Response to October Review Panel Comments

Project Number: 12-1438

Project Name: Lower Nason Creek Reach Based Restoration RM 3.7 – 4.7

Figure 8. Anticipated channel changes in the next 20 years under the No Action alternative.

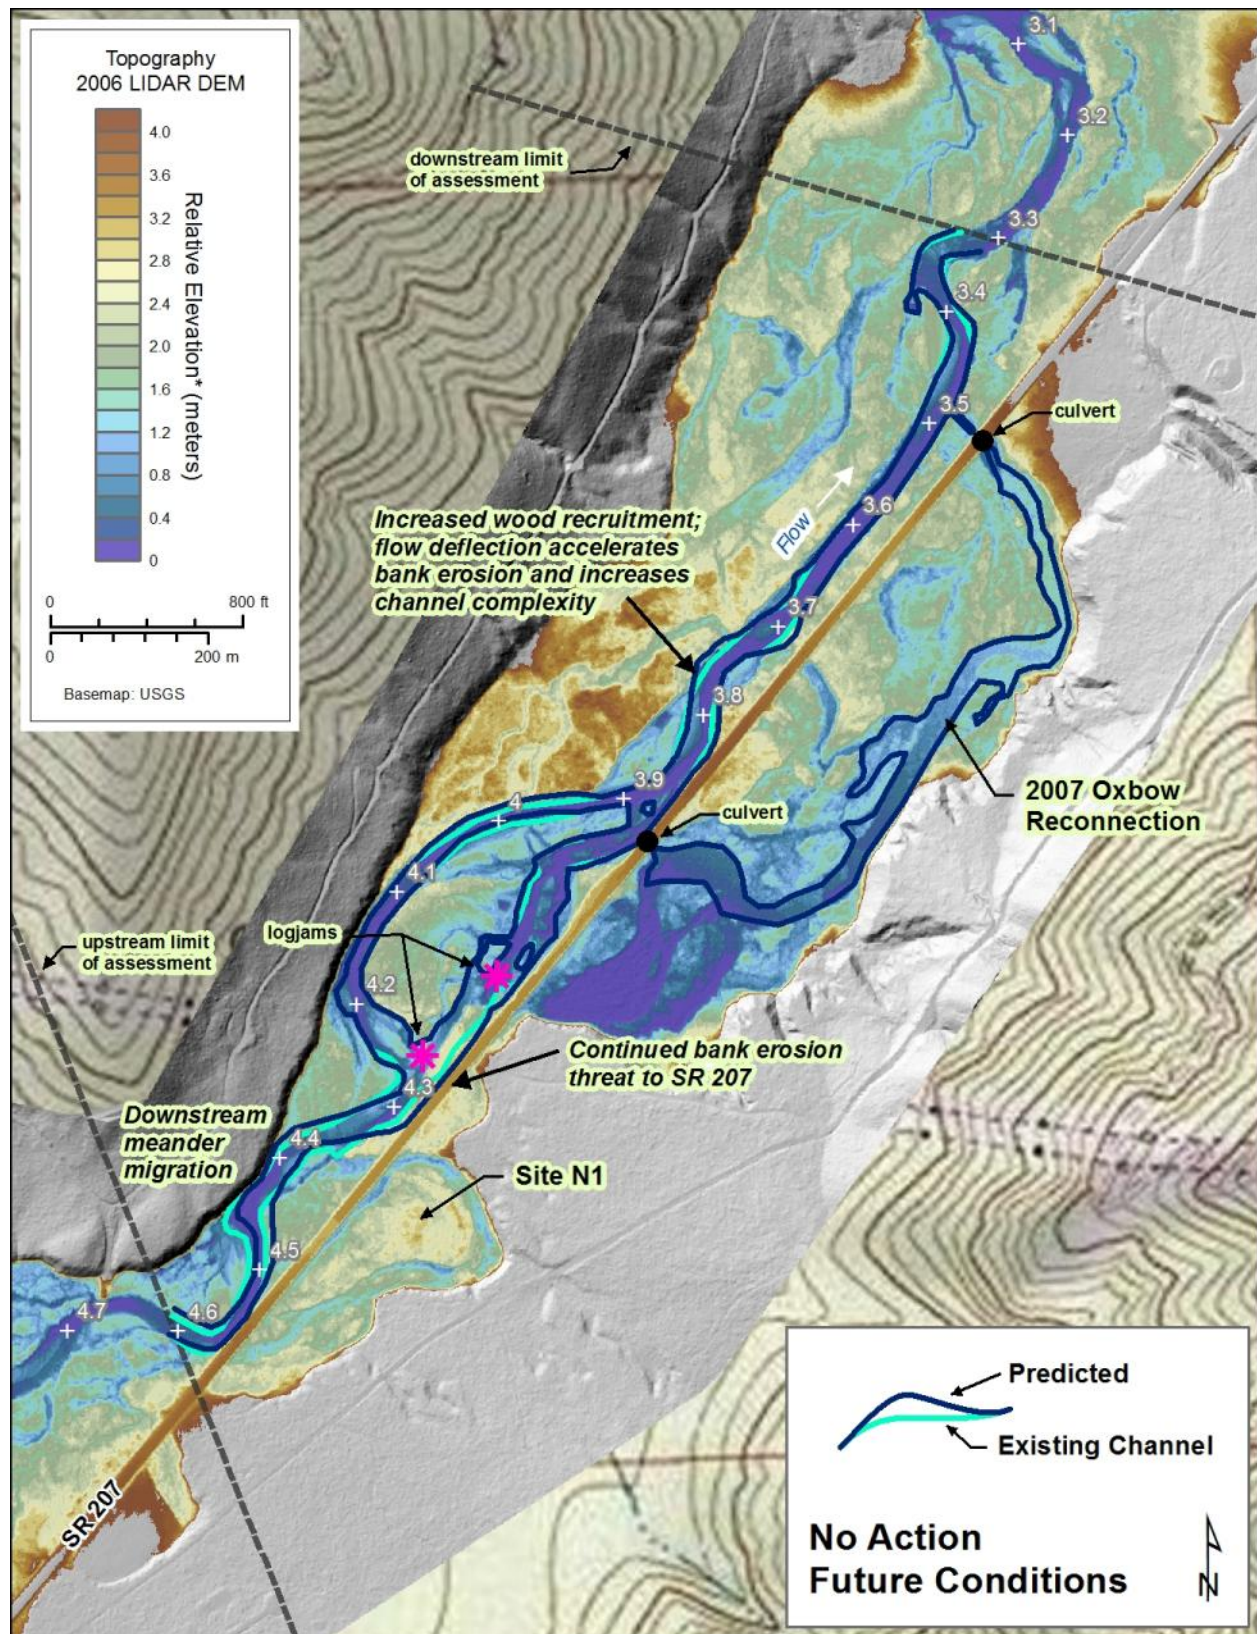
The Review Panel was initially under the impression that the proposed large wood jam at RM 3.7 was located at the inlet of an existing side channel. An examination of the Lidar DEM, however, suggests that the wood jam would be located at the outlet of a side channel that is already at or below Nason Creek's bankfull elevation. The project sponsor should justify the placement of the proposed ELJ at this location and clarify how the proposed structure would increase the extent and duration of inundation in this floodplain feature.

The LIDAR indicates that there are active high flow channels throughout the river left floodplain from RM 3.4 – 4. Figure 8 in the Cardno-Entrix memo (and attached) depicts the relative elevation of these floodplain channels. Placement of a large wood structure near RM 3.7 would increase floodplain interaction near that location. Modeling results would indicate the upstream and downstream extent of increased floodplain interaction on river left. Modeling results could be provided to SRFB as a review milestone prior to the final selection of the ELJ location.
